## Memo

### Development Assessment

**Subject:** DA2021/0200 – 1100 Barrenjoey Road PALM BEACH - Additional submission and additional information received

Figure 1 – Extract from Addendum Arborist Report explaining changes to plans, figure from Rain Tree Consulting dated 13 July 2021.

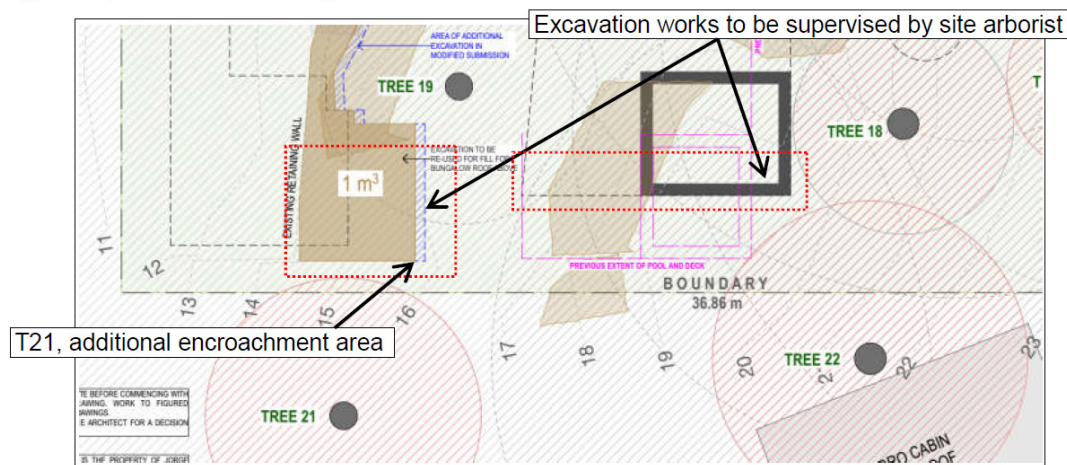
Following receipt of this, Council wrote to the applicant requesting the applicant's geotechnical engineer and arborist provide addendum reports that referenced the latest issue of architectural plans and provide a response to the concerns raised in the submission. It is noted that the latest issue of plans have maintained the same setback for the secondary dwelling and increased the setback for the pool adjacent to the southern boundary (shared with 1110 Barrenjoey Road). A slight increase in the excavated footprint of the secondary dwelling resulted from the amended plans, the changes shown in the below figure and are minor in nature.

The applicant’s Addendum Arboricultural Report reviews and comments on the latest issue of plans and note that the recommendations within the original Arborist Report can continue to apply. It is noted the amended plans provide an increased setback to the pool from the southern boundary and an increased setback from T22. The setback to the southern boundary for the secondary dwelling remains unchanged, with a slight increase in excavation footprint to the east. Council’s Landscape officer has reviewed the addendum report and is satisfied the amended plans will not have an unacceptable impact on T21 and no additional conditions need to be recommended above what is already in the Council assessment report. Condition 1 within the assessment report is recommended to be updated to refer to the addendum arborist report.
